2 May 2013 Our Ref: OUT13-02727

Mr Marcus Crudden Essential Services Commission Spring Street MELBOURNE VIC 3000

1. Response to Draft Determination – OPERATING COSTS

Guaranteed Service Levels (GSLs)

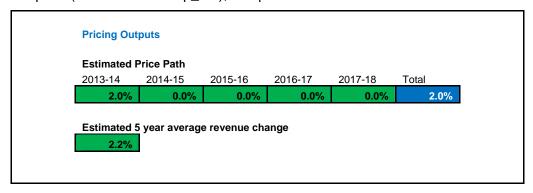
ESC draft determination regarding new GSLs includes a previous GSL regarding water interruptions that was submitted in our **draft WP3**. Initially WPW proposed that all unplanned water interruptions would be restored within 5 hours of notification as a guaranteed service level. Feedback from customer consultation placed this service as a low priority, which may be a direct result that 60% of our customers do not live permanent in our region. An alternative GSL was proposed in our **final WP3** submission. The proposed GSL is based on no more than 5 unplanned interruptions within any 12 month period.

Westernport Water seeks further clarification that the ESC approve the proposed GSL, not the GLS included in table 2 (p.4) of the draft determination.
